#### Dover District Local Plan to 2040

### Eythorne Parish Council Regulation 19 Consultation Response

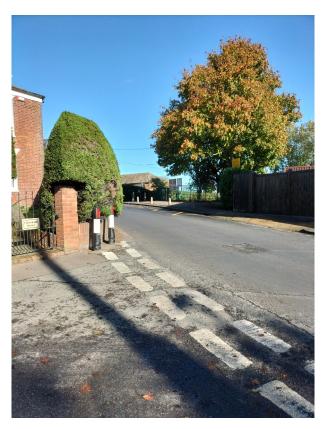
- 3.3.2 The development area SAP29 is identified to be accessed via Beech Drive (USRN 11300097) which is an Unclassified road. It is worthy of note that the additional traffic movements generated by SAP29 will need to be considered alongside SAP28 as it is realistic to foresee that traffic from SAP29 will predominantly travel towards Sweetbriar Lane, Terrace Road, Adelaide Road and Church Hill. It is felt unlikely that traffic will take a route via Milner Road to exit Elvington unless the journey is specifically to access the local retail in Adelaide Road. In addition Sweetbriar Lane at its southerly end where it joins Terrace Road is very narrow, approximately 4m in width, has substandard visibility, contains concealed entrances and supports on street parking, all of which would render this route unacceptable for additional motor vehicle movements.
